## CONFIRMED MINUTES

## SPECIAL COUNCIL MEETING

**2 MAY 2023**

## 6.2 Referral Advice - Revised North Stoneville Townsite Structure Plan 34

Figure 4. Revised SP34 Network Improvements (Officer concerns in red)

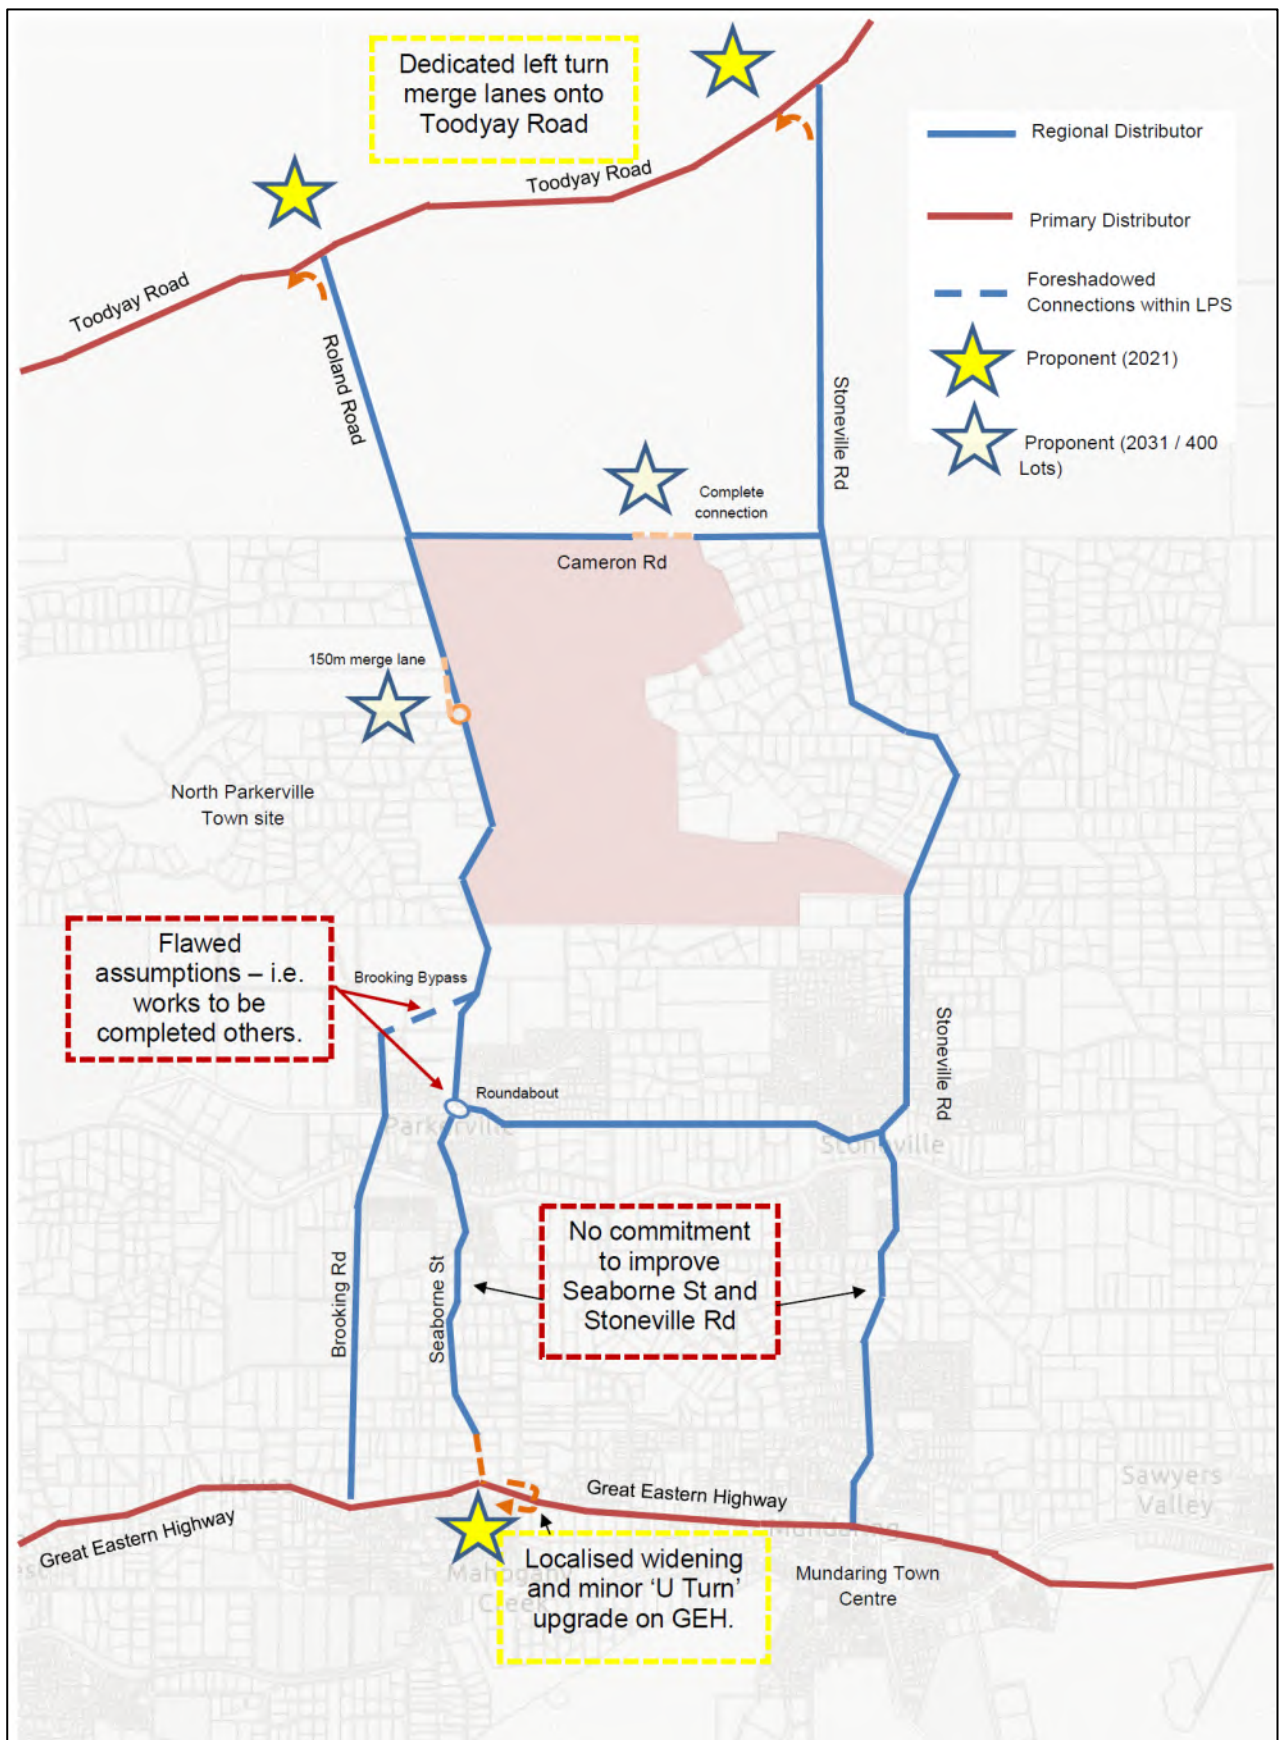
The TIA has been peer reviewed. A summary of the external strategic improvements and when they will be implemented are illustrated in Figure 4; noting this diagram is the Shire's officers attempt to consolidate visually statements made throughout the TIA, Bushfire Simulation Model and Structure Plan Document Part 1.

Figure 5. Evacuation model identified critical issues with northern escape onto Toodyay Road

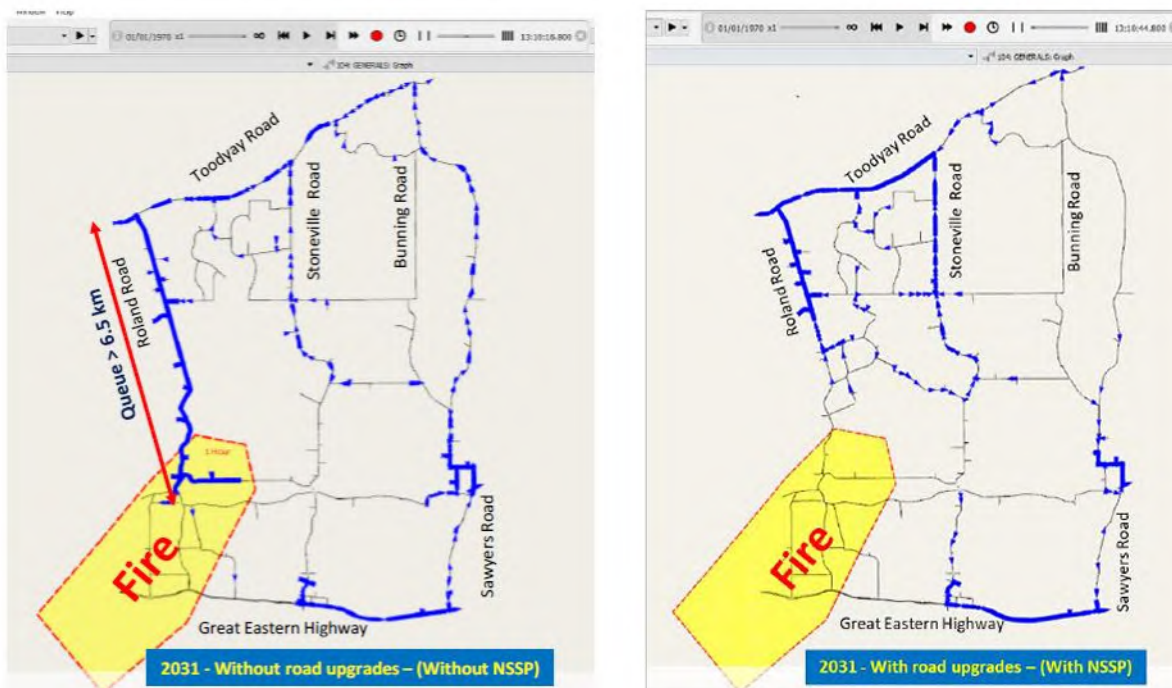
The Microsimulation Evacuation Modelling Report, presumably informed by state government expectations/parameters, concludes that existing intersections at Roland / Toodyay and Stoneville / Toodyay currently fail to provide safe evacuation options for Shire of Mundaring and City of Swan residents (refer to Figure 5).

The proponent now claims the development SP34 will deliver a safer evacuation scenario than the existing situation, as the revised SP34 will involve the construction of dedicated left hand turns onto Toodyay Road from Roland Road and Stoneville Road.

Officers note that another interpretation of these results is that state agencies and in particular, Main Roads WA / DFES, have not yet had the benefit of this modelling. The onus should rest with State agencies to resolve these deficiencies with the network, regardless of SP34. The modelling outcome cannot reasonably justify SP34 – and it is recommended Main Roads WA be requested to progress upgrades to Roland and Stoneville Roads as a matter of priority.

Figure 6. Shire officer comments. Environmental considerations

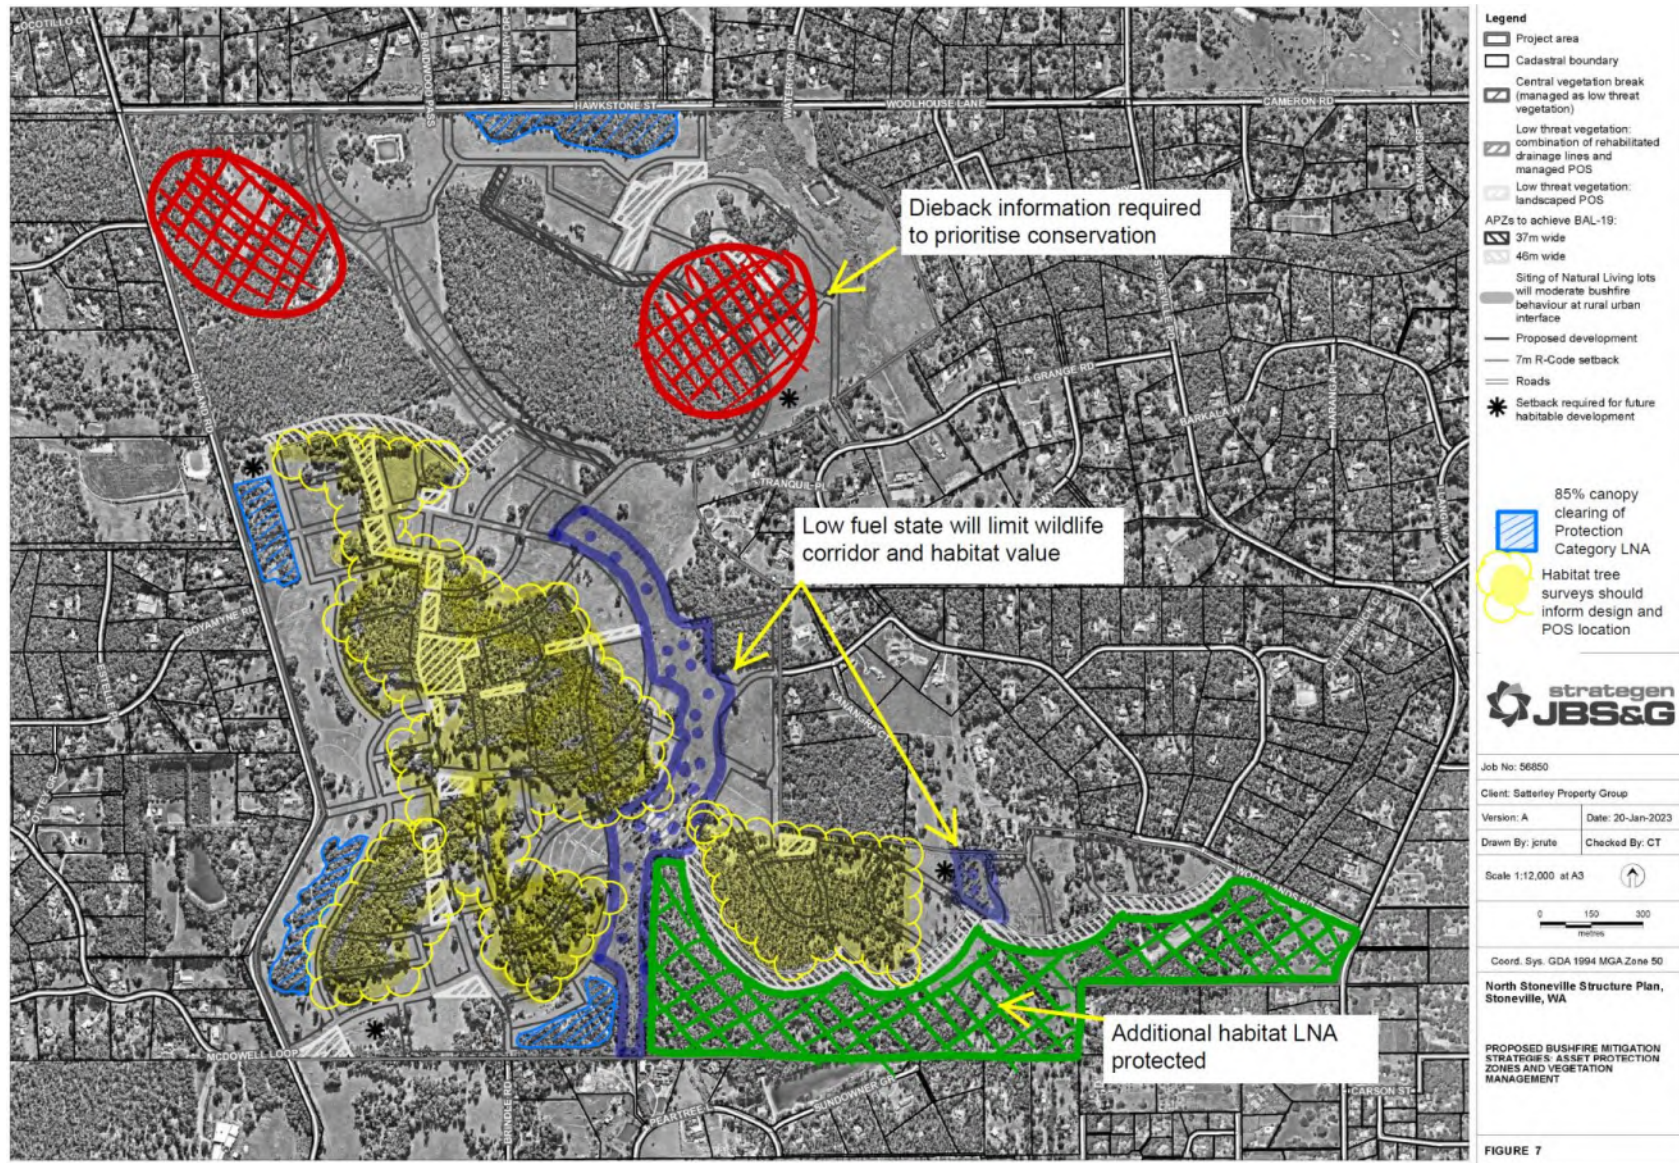
Given the passage of time, it is noted that the proponent could have completed more detailed mapping and ensured this informed the urban design response, however this has not occurred (see Figure 6). Ordinarily the Shire expects structure plans to be designed around and respond to key environmental features. This has not occurred as there is a presumption that the urban cells can be completely cleared.

The requirement to maintain the linear POS following a watercourse north-south as low threat vegetation is inconsistent with the Shire's adopted Watercourse Hierarchy Strategy and will limit the health and habitat value of the watercourse. It is also not clear the extent to which revegetation will be able to be achieved immediately surrounding the retained waterbodies.

**FIGURE 24: INDICATIVE PUBLIC OPEN SPACE PLAN**  
Plan produced by Hatch RobertsDay, 2022

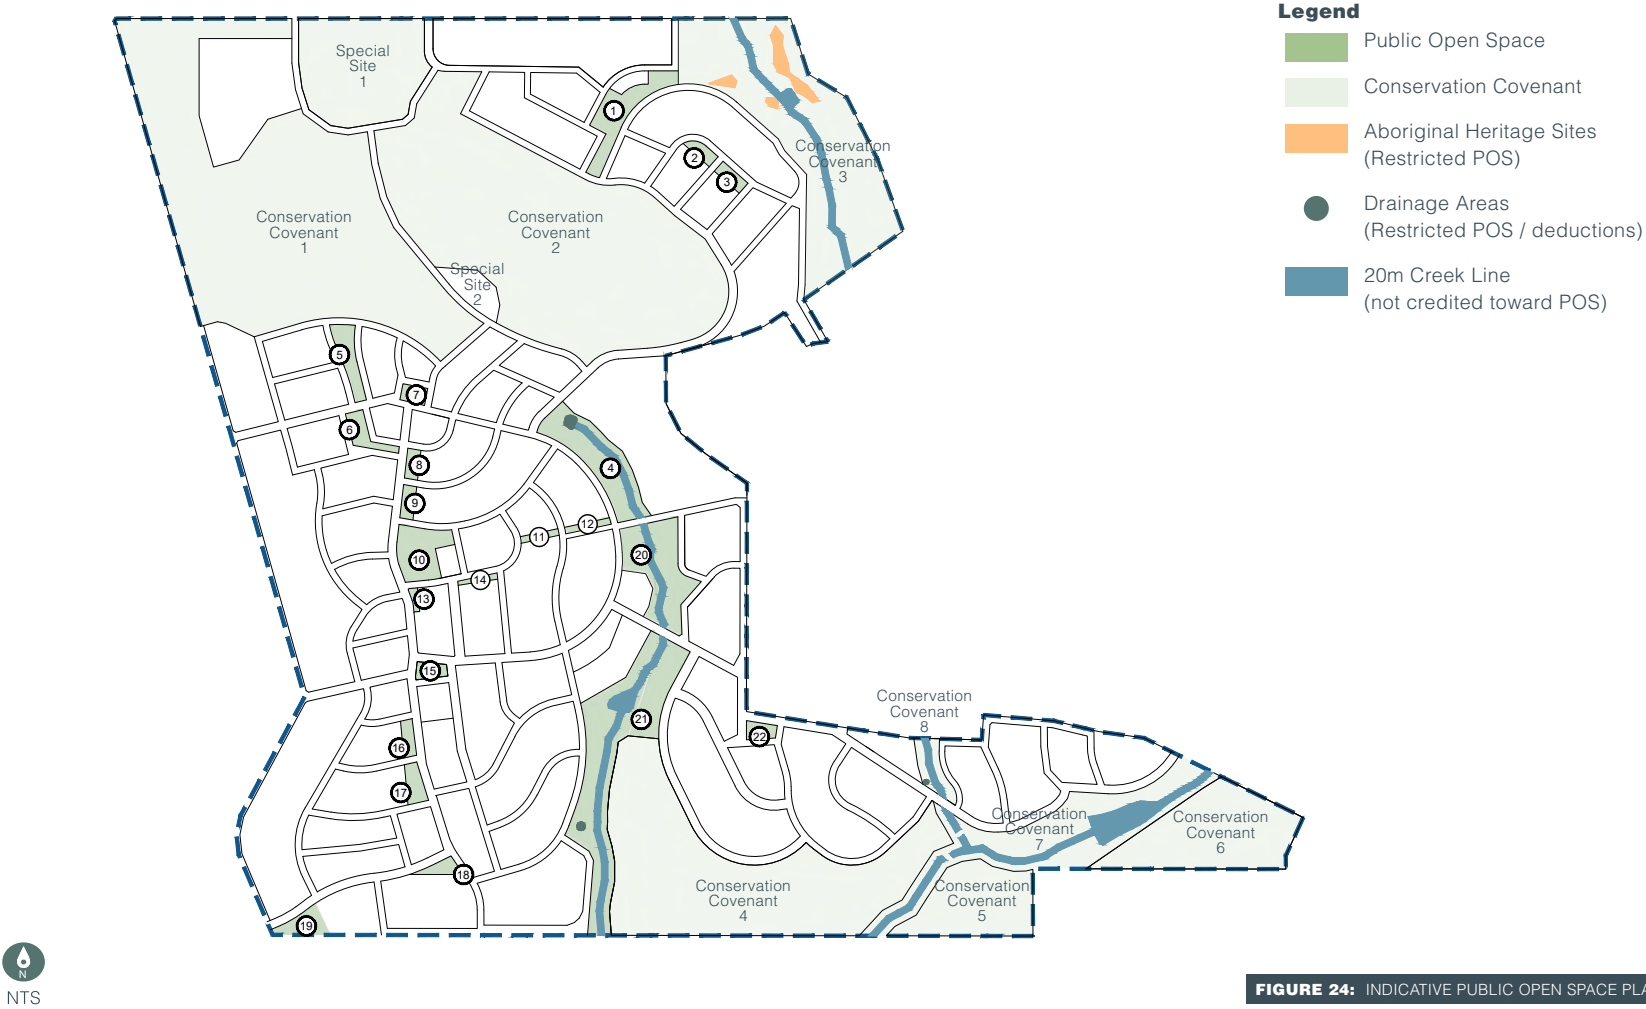
- Part 1 - Plan 1
  - Area east of the Recycled Water Facility (RWF) is identified as a Special Use site in Figure 24 (and in other documentation in Appendices); however this use conflicts with the purpose of 'Conservation / Recreation' reserve shown in Plan 1.
